Planning Commission MEETING AGENDA

Thursday, April 20, 2023 - 1:00 PM
Council Chambers, Easton Town Office
14 S Harrison Street

Plan Review Comments

FOR
NAIMA - PHASE 2
INFRASTRUCTURE IMPROVEMENT PLANS
TAX MAP 0104, GRID 000EA
ELECTION DISTRICT 01-001, TALBOT COUNTY, MARYLAND
PREPARED FOR NAIMA VENTURES, LLC

SHEET NO.:
C-401.01

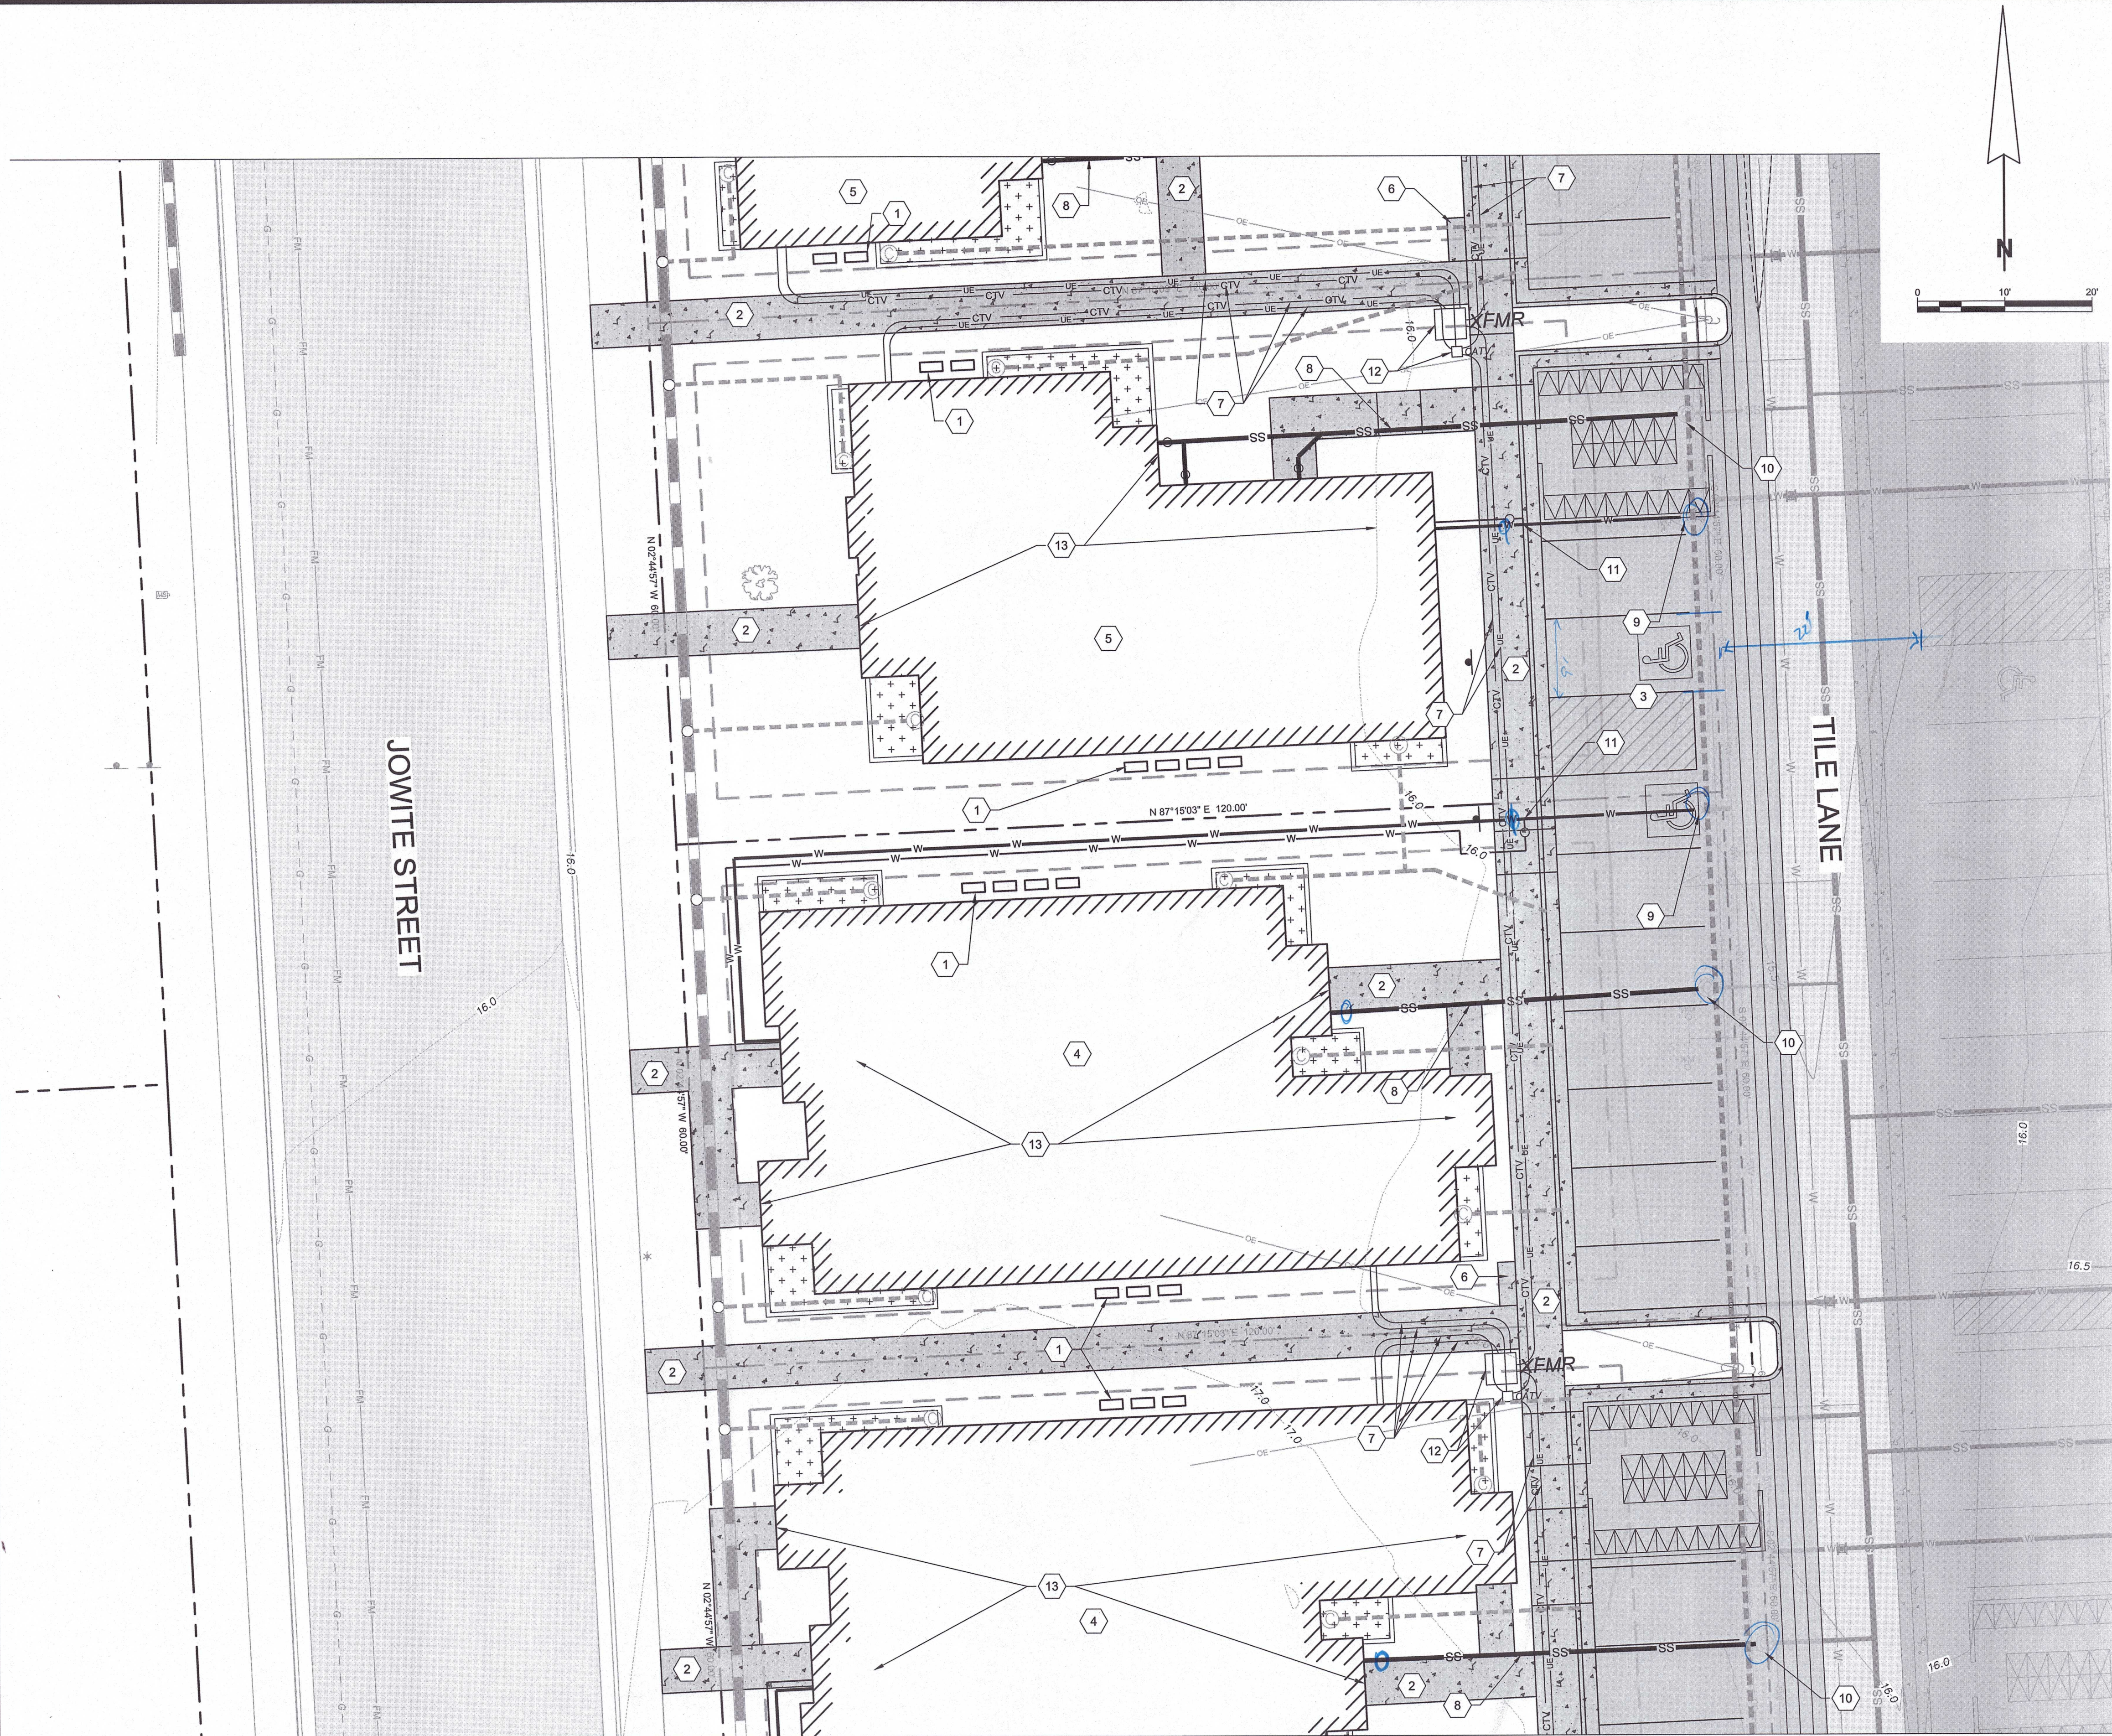
ITEM:	DRAWING / PAGE	COMMENTS:
1	General	2" Communications conduit to follow electric
2	General	Provide digital drawing to Easton Utilities for electric design. Easton Utilities to abandon overhead electric on Tile Lane. Poles turned over to Verizon after electric removed. Is Verizon abandoning overhead?
3	General	Contact Will Cottingham for addressing
4	V-101.1 V101.2 V101.3	Water services and sewer laterals to be abandoned at property. Pits and cleanouts to be removed if not reused. Unused sewer, if connected to new sewer main and shall be abandoned to the main.
5	C-203	Crossings not shown
6	C-401.1	Water main to be extended past garbage can corral. Valves and cleanouts shall not be in parking area.
8	C-401.1	Water main, sewer laterals, water meter pits etc shall be abandoned properly according to Easton Utilities requirements.
9	C-401.1	Water meter pits not shown in easement.
10	C-401.1	Valves shall be added to fire service

11	C-401.1	Sewer cleanout shall be located at ROW and 5' from building envelope
12	C-401.1	Contractors to confirm sewer main use. If not use, abandon gravity sewer.
13	C-401.1	Show sewer manhole on Jowite
14	C-401.02	Show parking space lines at 20' to show distribution of utilities.
